Republic of the Philippines
Department of Education
REGION VIII - EASTERN VISAYAS

To	: ALL PROSPECTIVE BIDDERS
Project	: PROCUREMENT FOR CONSTRUCTION OF OFFICE EXTENSION AREA OF FINANCE DIVISION
Subject	: BID BULLETIN NO. 1
Date	: August 31, 2022

This Supplemental Bid Bulletin is issued to clarify, modify, and amend certain provisions/specifications in the Bid Documents for the abovementioned project. It shall form part of the Bid Documents and supersedes provisions therein that are inconsistent herewith.

PERSPECTIVE

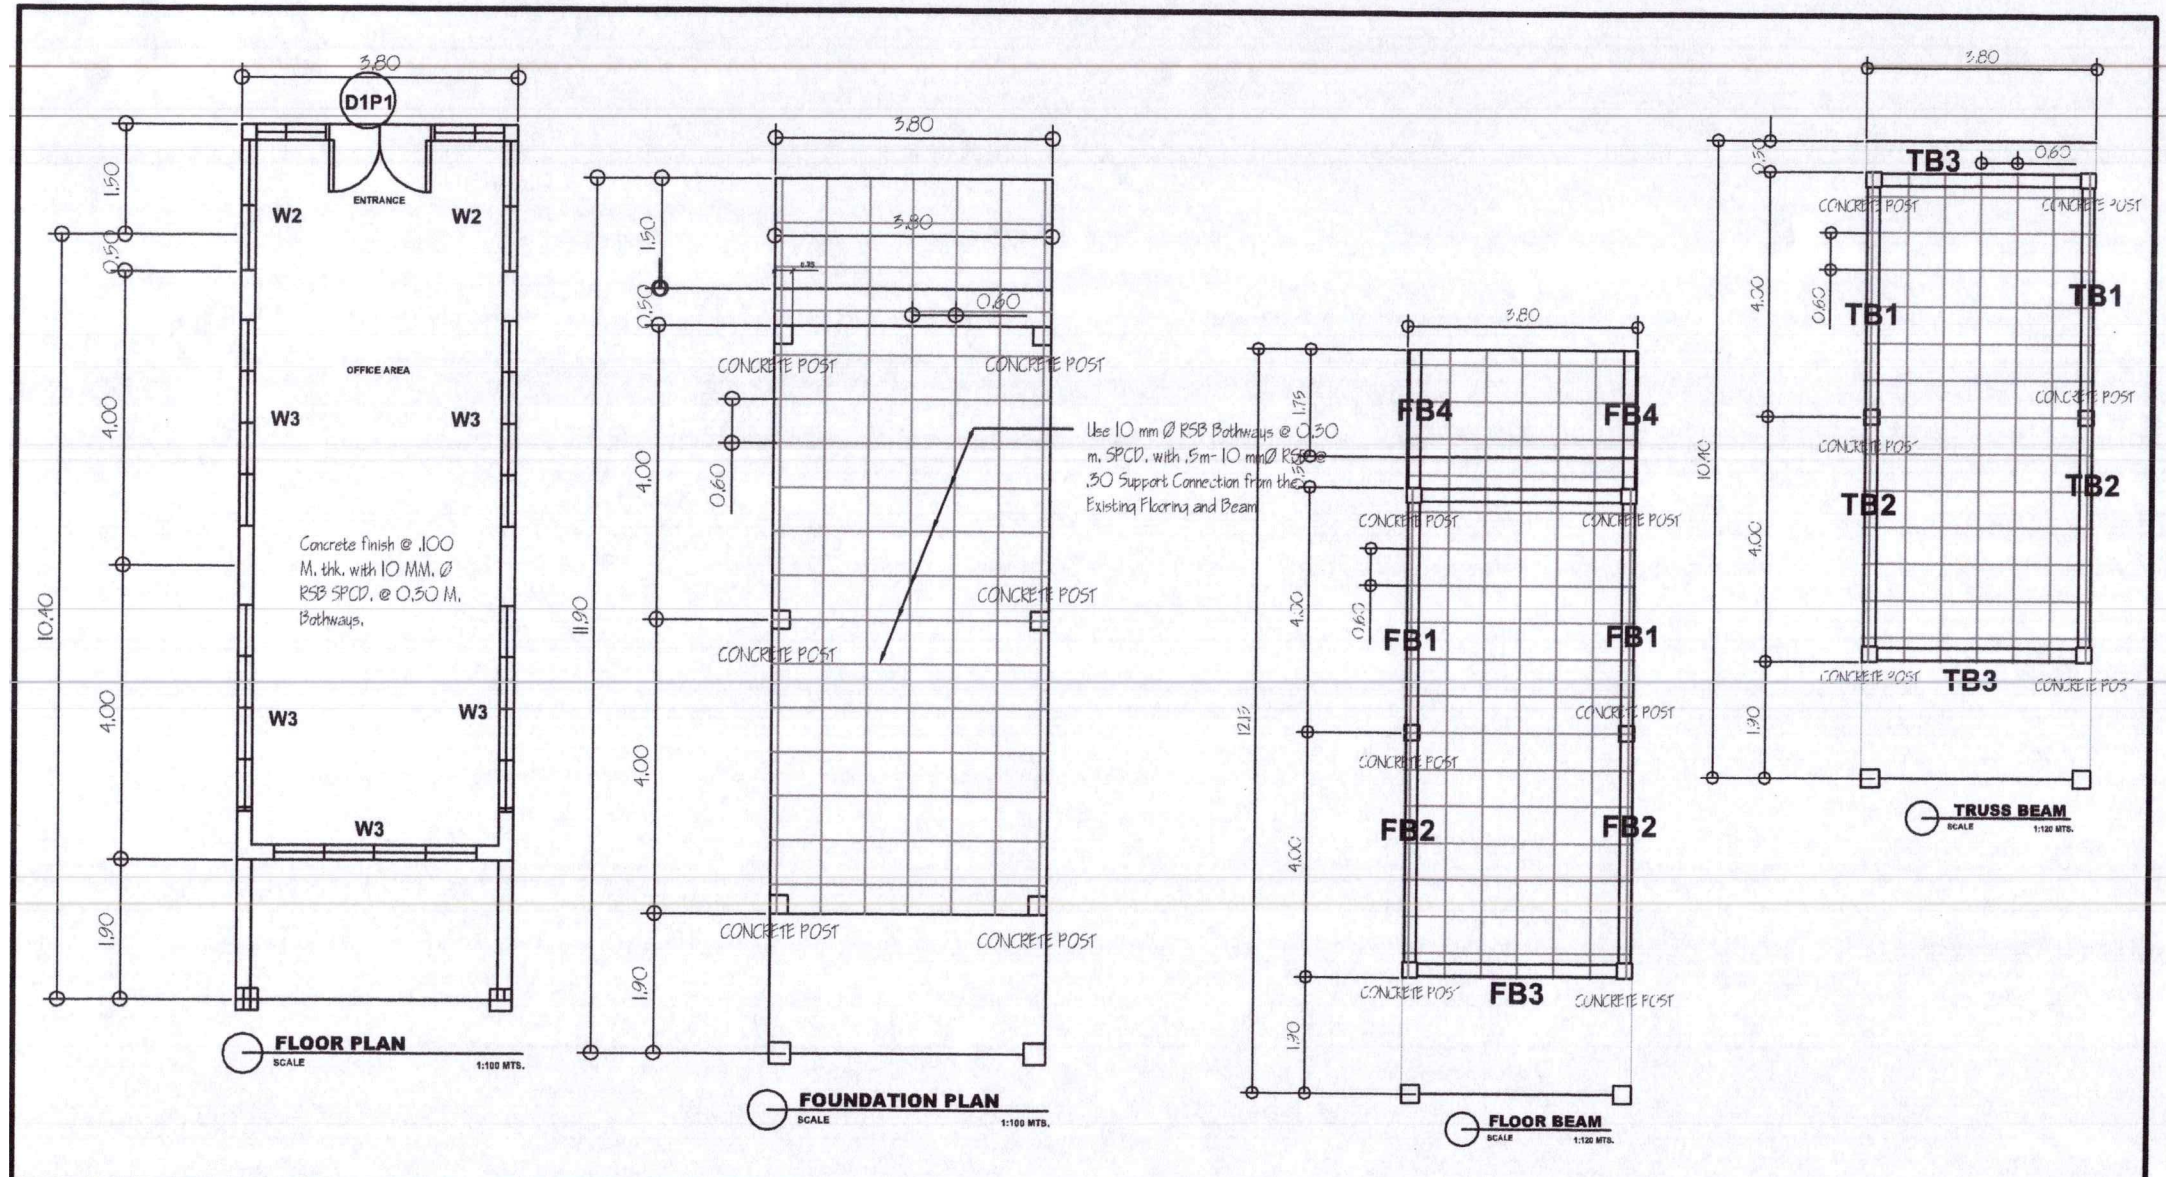
Particulars	From	To
• Section VII. Drawings	Perspective	Perspective with Approved Plans and Specifications
• Section VIII. Bill of Quantities	I. Materials II. Labor III. Direct Cost (I+II) IV. Indirect Cost 10% of (1- Gen. Req.) V. Tax 5% of (III+IV) VI. Project Cost (III+V) VIII. Total Project Cost (VI+VII)	I. Materials II. Labor III. Direct Cost (I+II) IV. Indirect Cost 10% of (1- Gen. Req.) V. Tax 5% of (III+IV) VI. Project Cost (III+IV+V) VII. Total Project Cost (III+IV+V)
